ADDENDUM

Supply and E&C of Side Beam for WT-4&5

Tender Ref: 77/21/6072/DSP

1 x 700MW BTPS-3, WT-4 & WT- 5 NEW BEAM SUPPLY AND ERECTION

IS-0-GA-656-103-M023

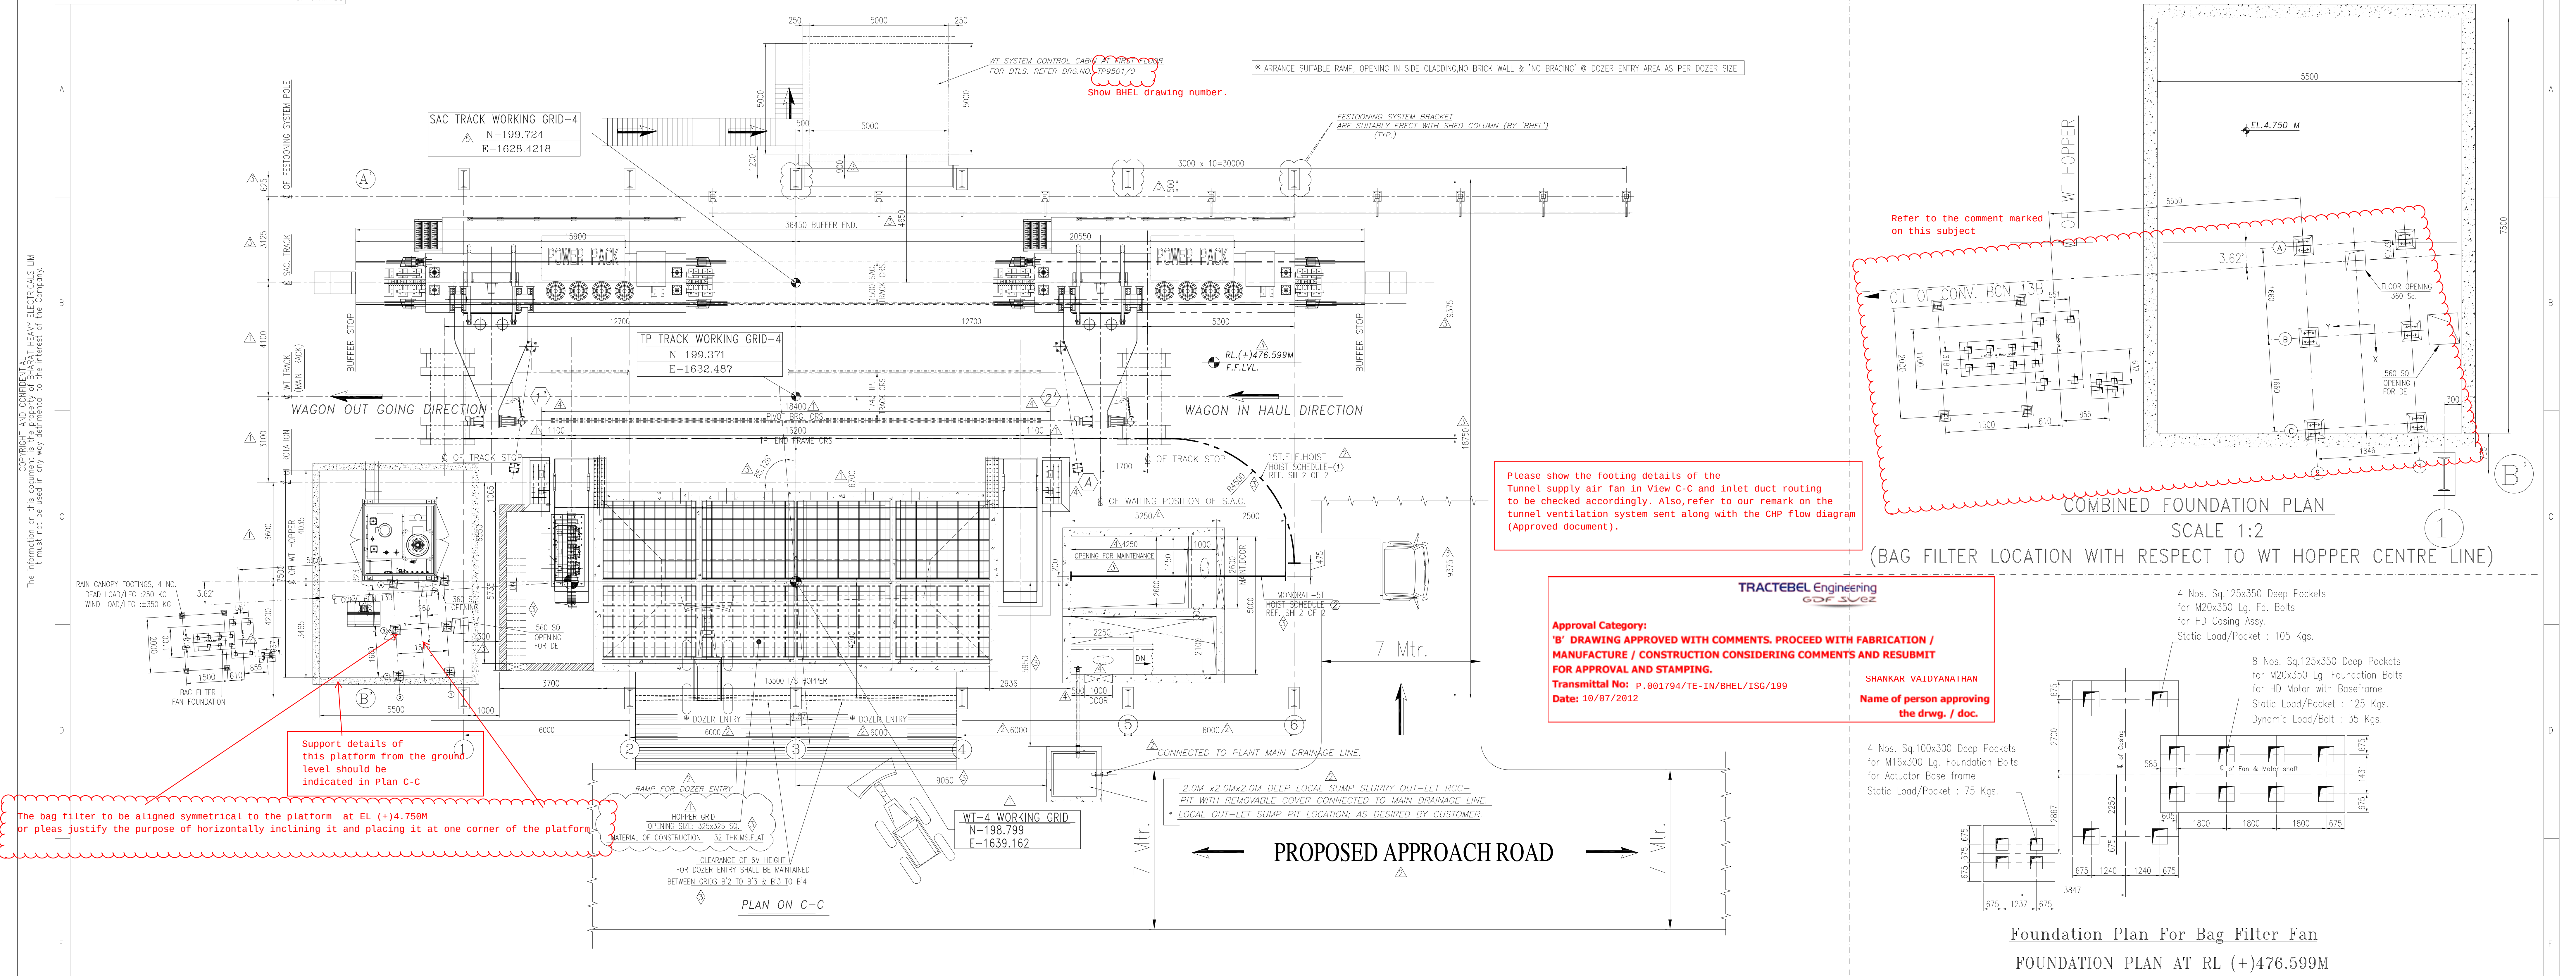
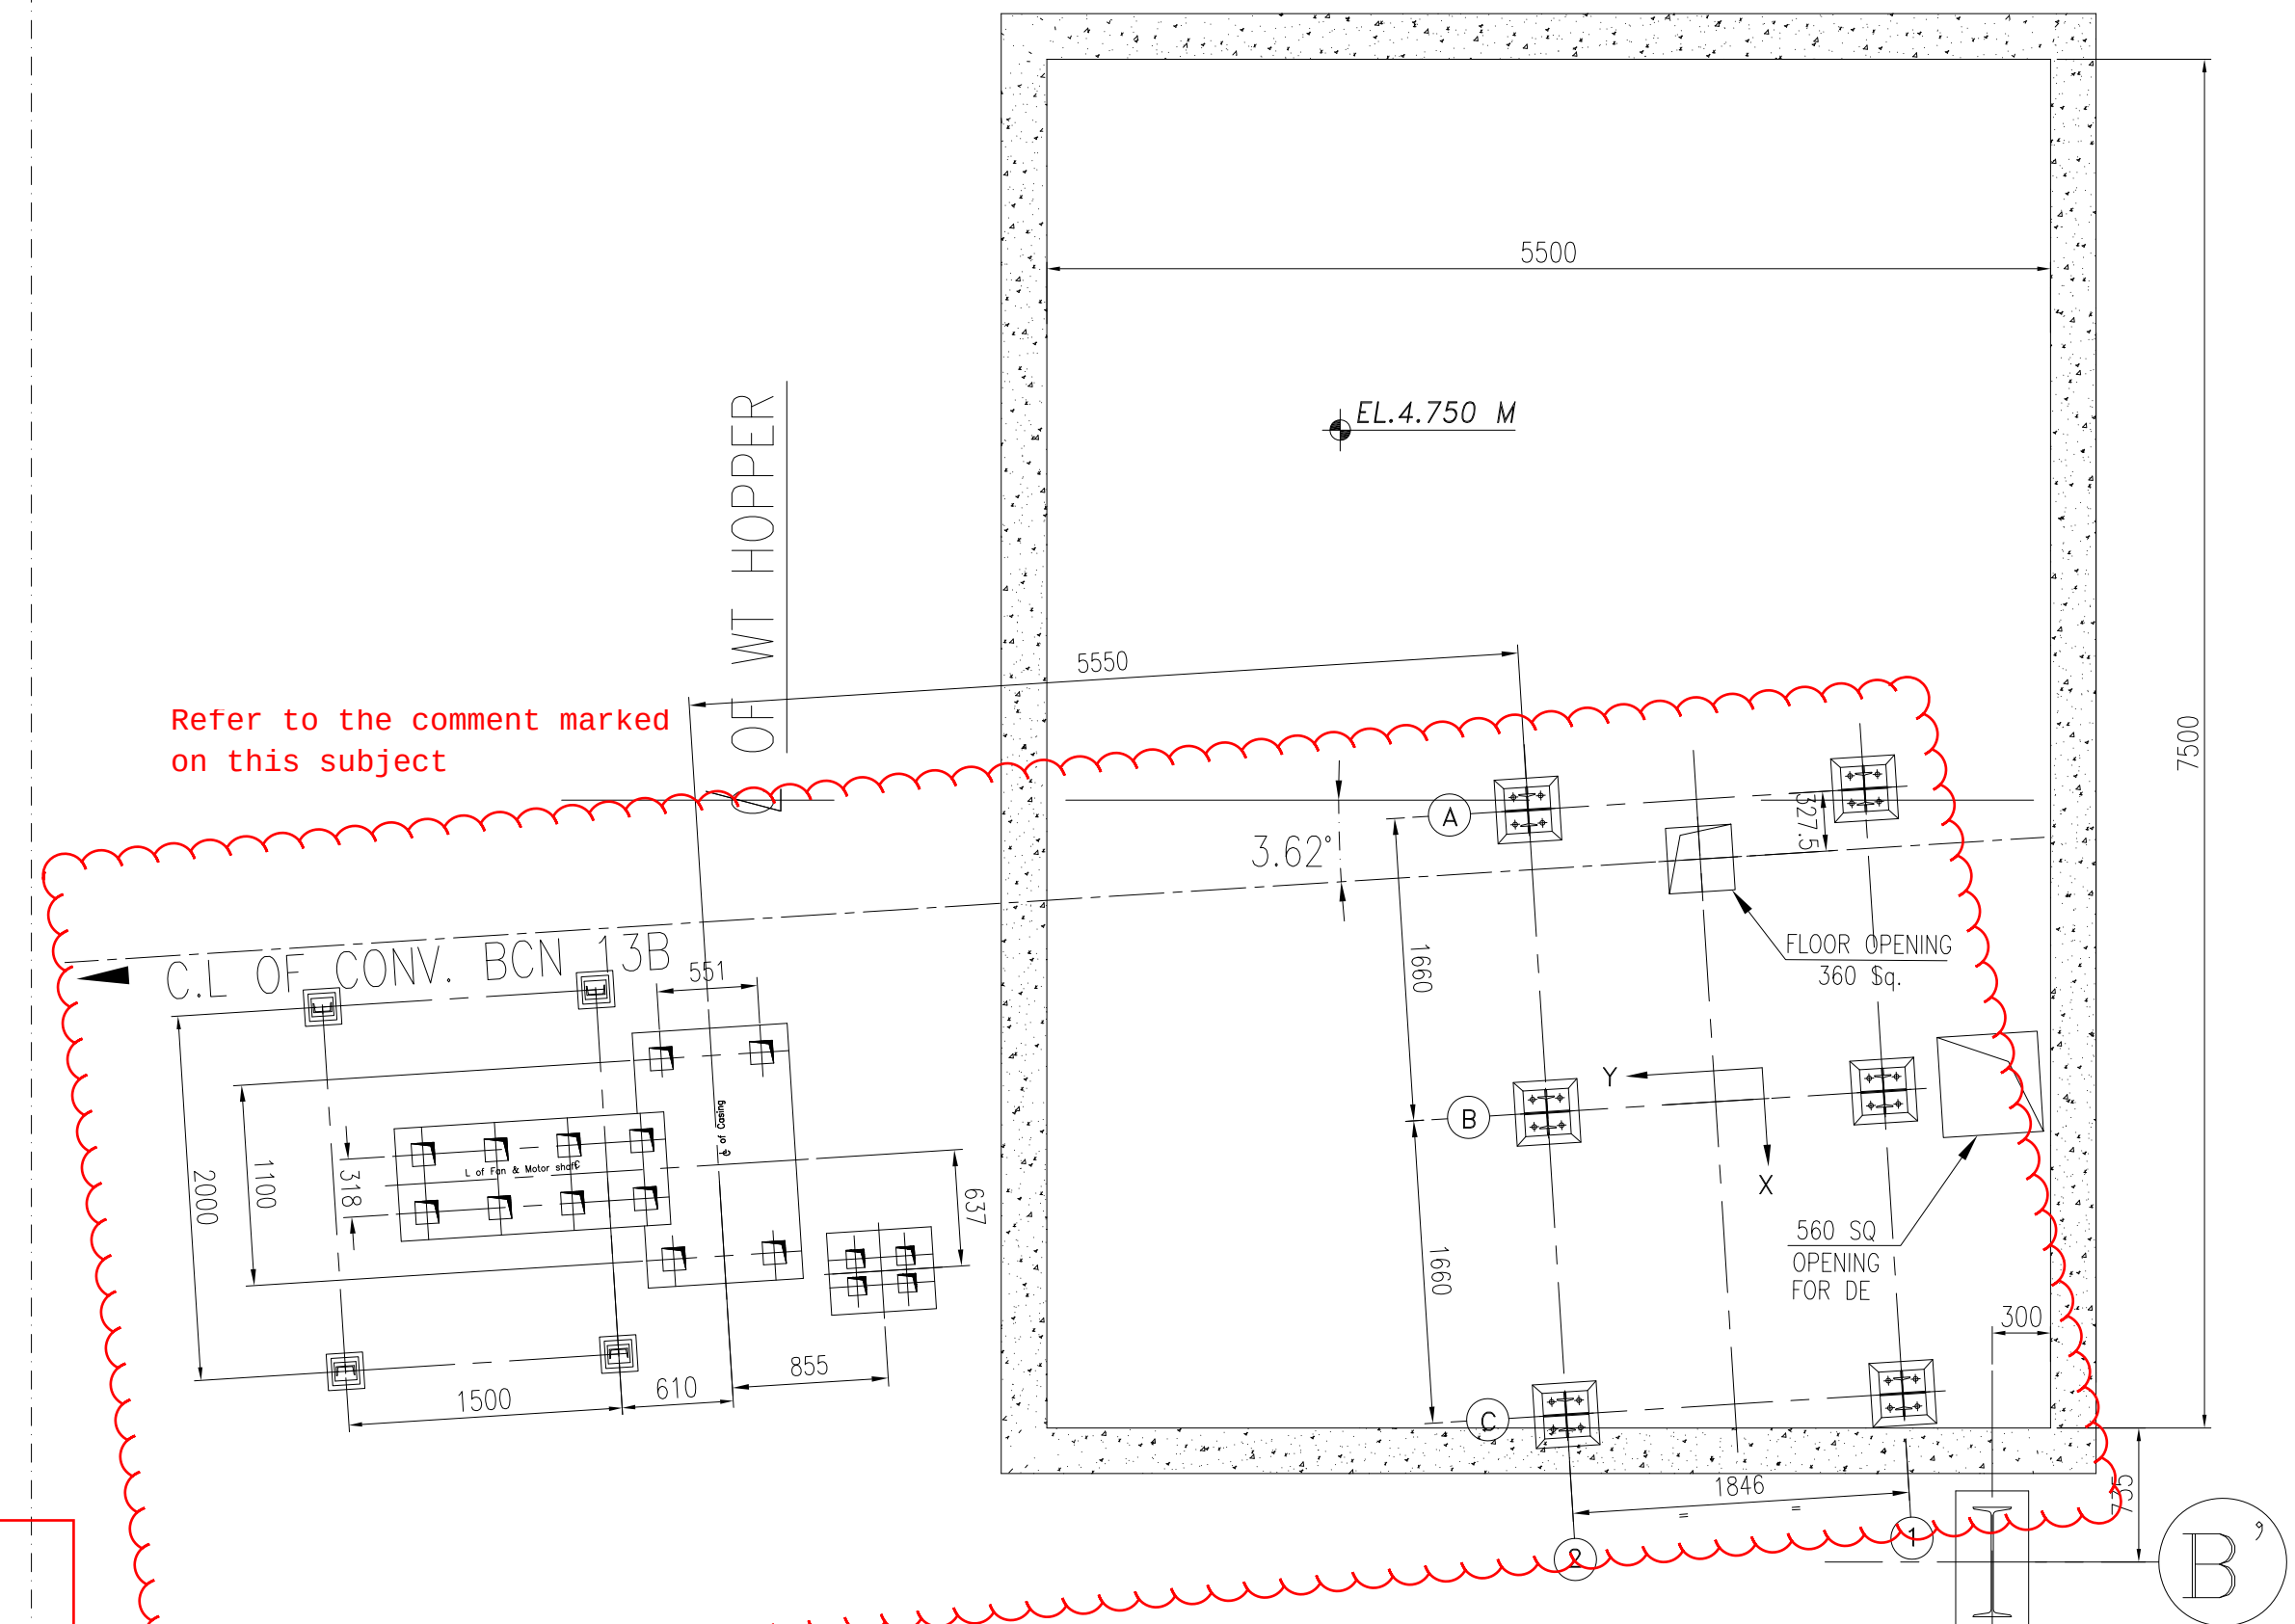
Please show the footing details of the Tunnel supply air fan in View C-C and inlet duct routing to be checked accordingly. Also, refer to our remark on the tunnel ventilation system sent along with the CHP flow diagram (Approved document).

REV. 03

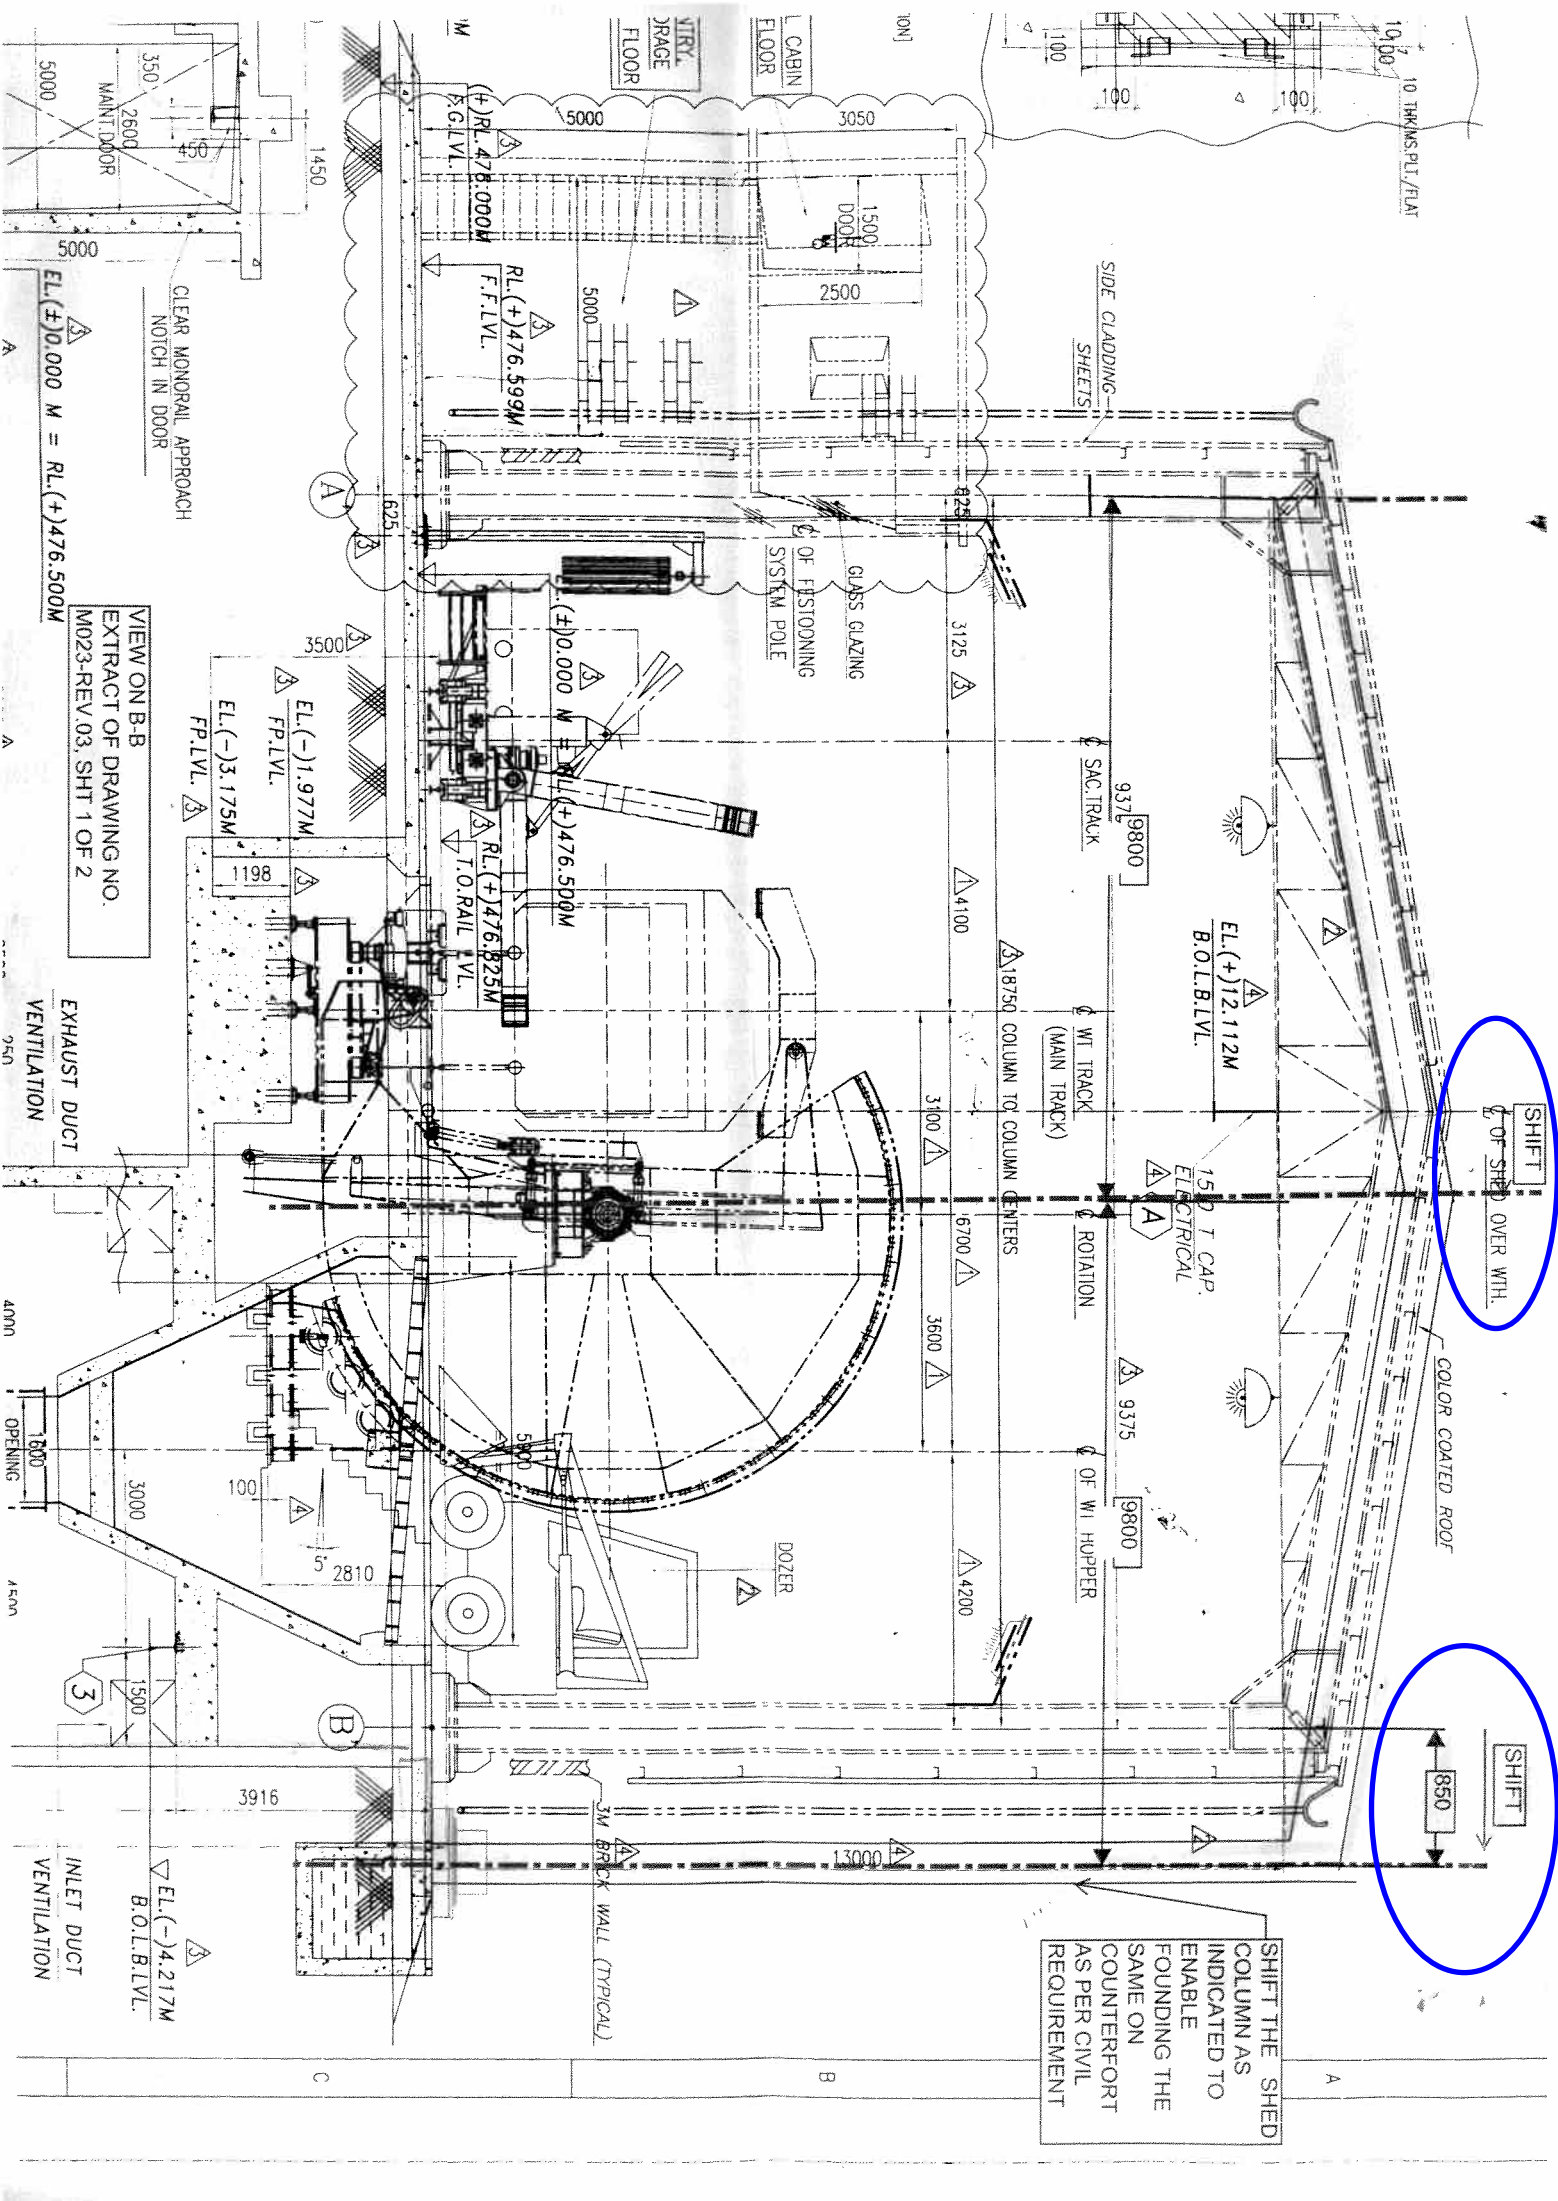
SHIFT
OF SHED OVER WITH.

SHIFT
850
